Haverford Township - Planning Commission

2. 380 Highland Lane, SS. Colman/John Neumann (SJCN) - Preliminary/Final Land Development Plan

**RE: Preliminary/Final Subdivision Plan
SS. Colman/John Neumann - 380 Highland Lane**

GRADING AND UTILITY PLAN
BUILDING ADDITION FOR
SS. COLMAN-JOHN NEUMANN SCHOOL
380 HIGHLAND LANE
HAVERFORD TOWNSHIP DELAWARE COUNTY, PA

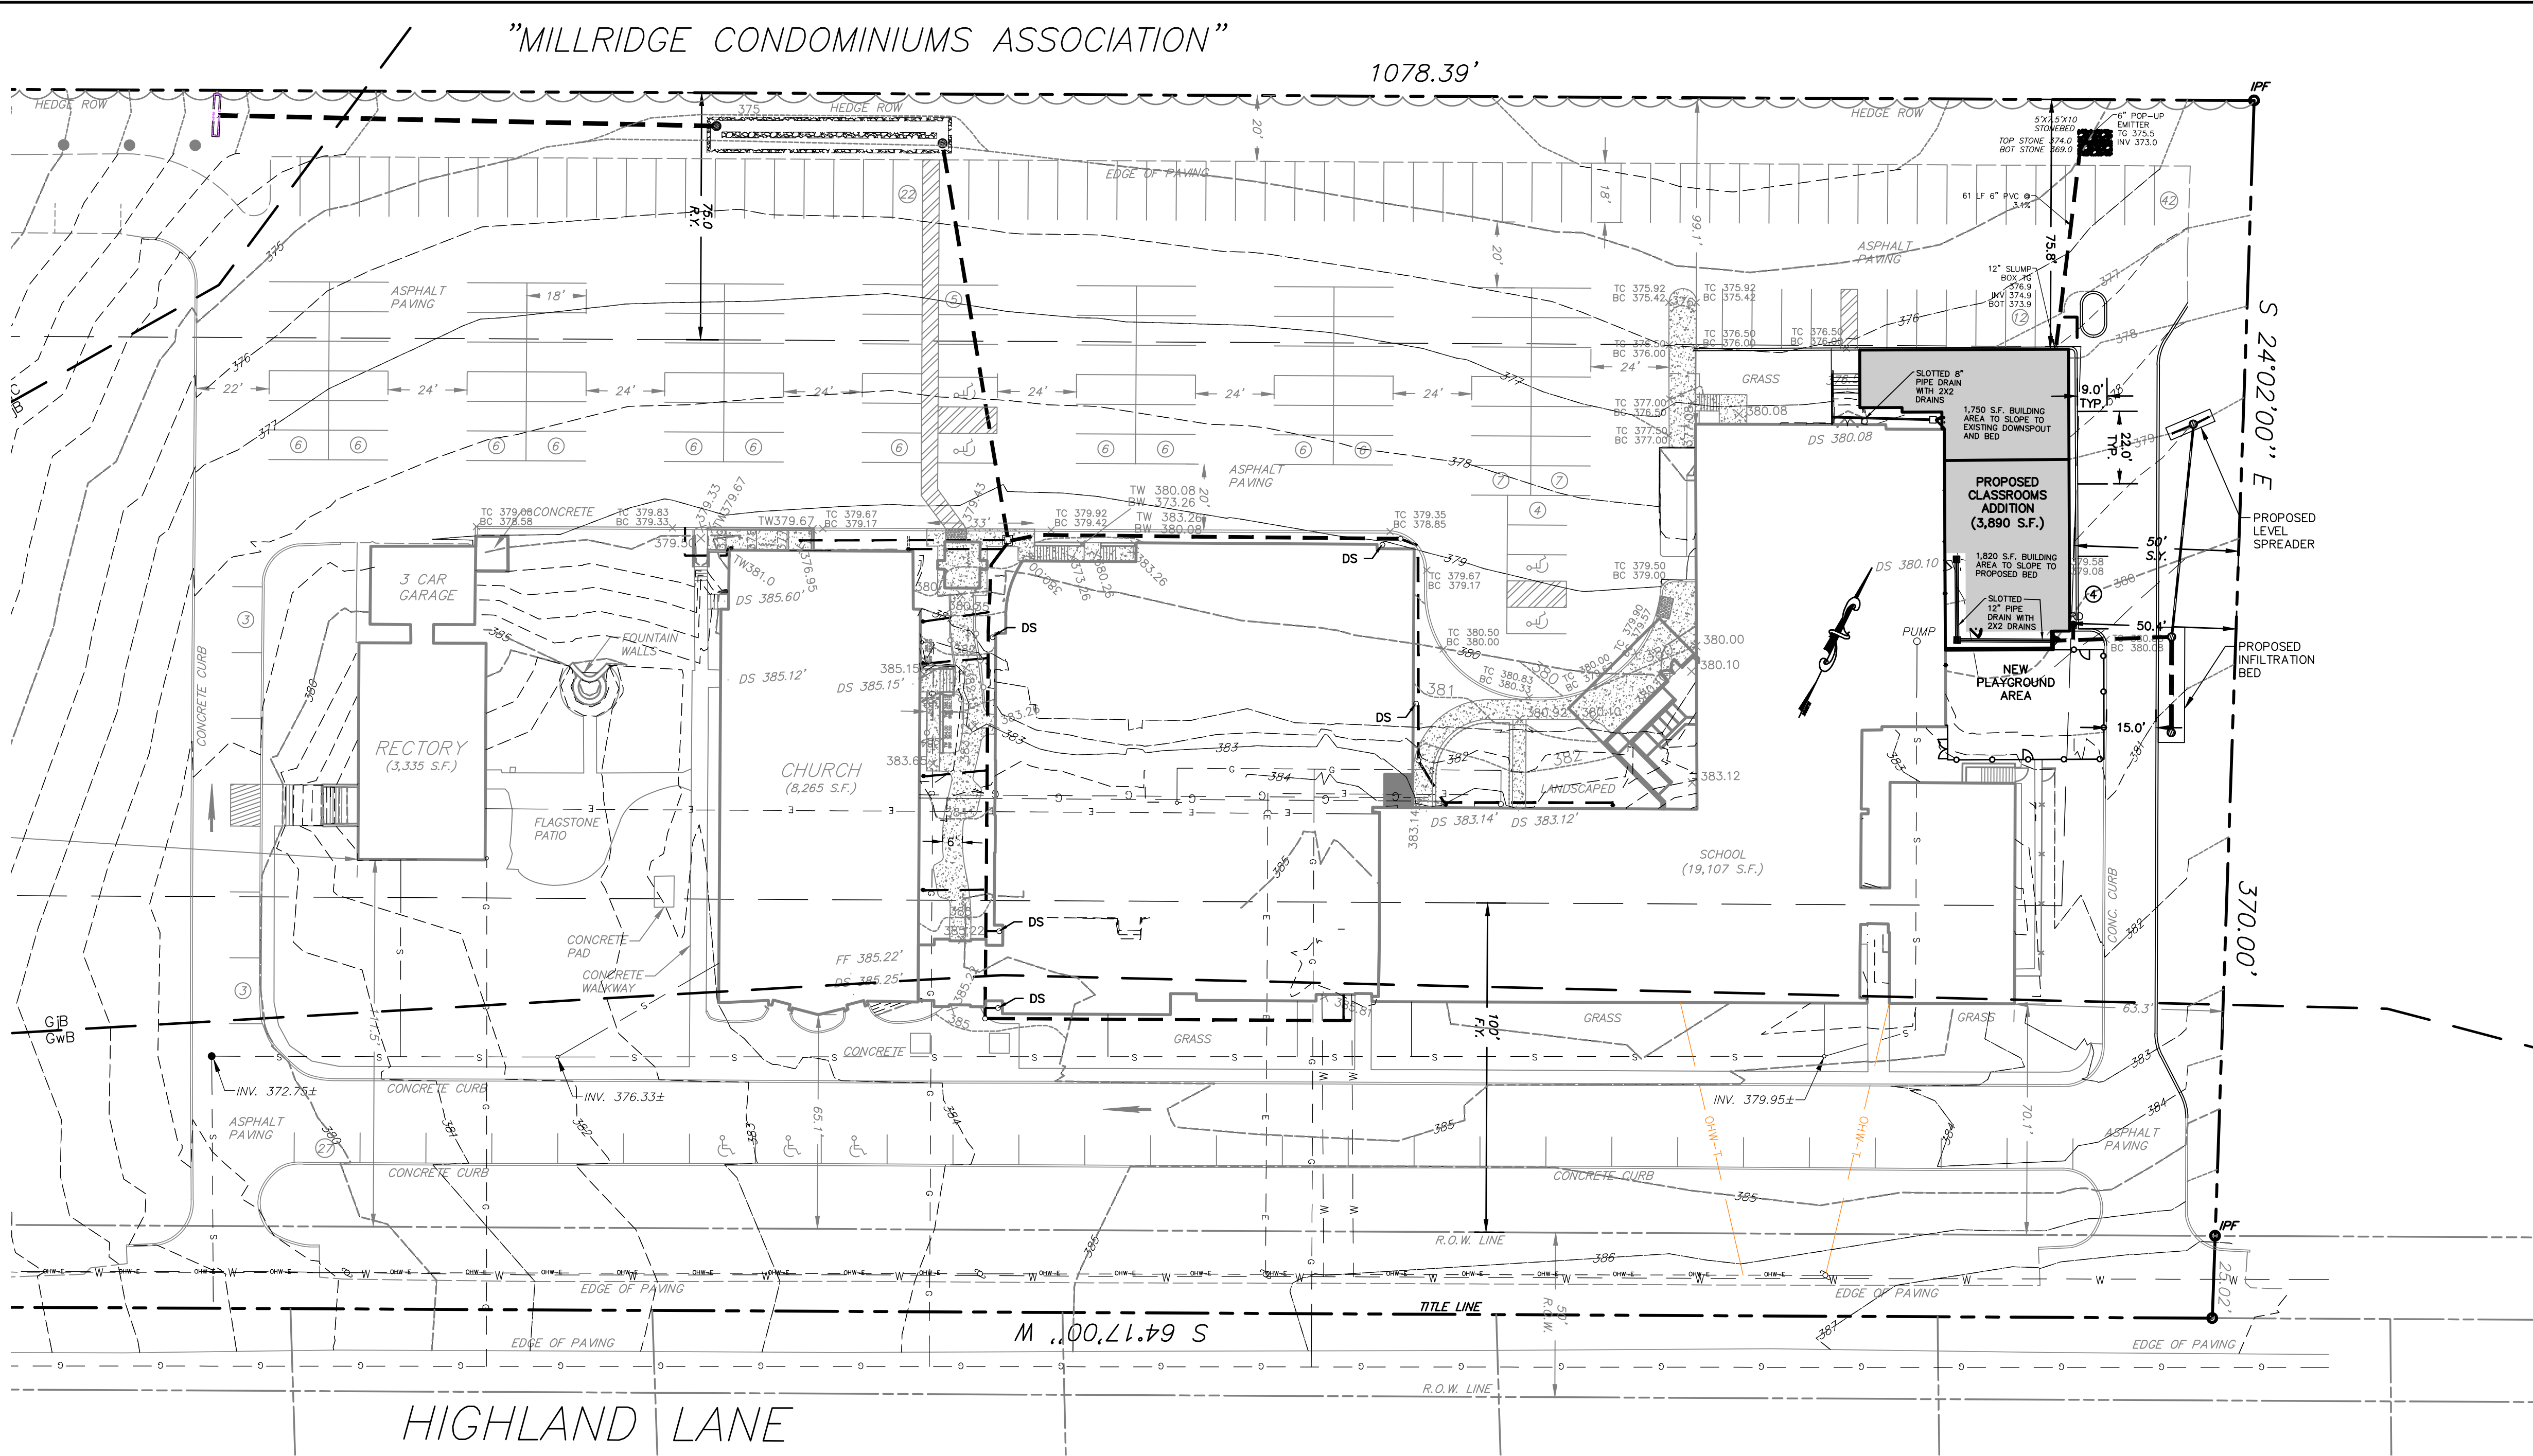
15. A tabulation of existing and proposed impervious surface should be provided on the plan. (§78-25.B(7))
16. Infiltration test results are required to be submitted. (§78-34.B(2)) The applicant has requested a partial waiver from this requirement to utilize prior infiltration test results. Previous test results should be included in the stormwater management report, and a note on the plan indicating that additional testing will be conducted during construction to confirm the design infiltration rate is to be provided.

17. A drainage area map is to be provided. (§78-26.A(3))
18. The invert of the proposed 8-inch outlet pipe indicated on the plan is inconsistent with the calculations.

21. Pretreatment is required prior to infiltration. The infiltration bed cross section and the detail for the Nyoplast drain basins should indicate a minimum 12-inch sump. (§78-36.A(1)[d])

25. The existing drive aisle on the west side is being reduced to 15-foot wide. The applicant should confirm this width is adequate for emergency vehicle access.
26. Appropriate signage should be added to delineate the new drive aisle is one-way.
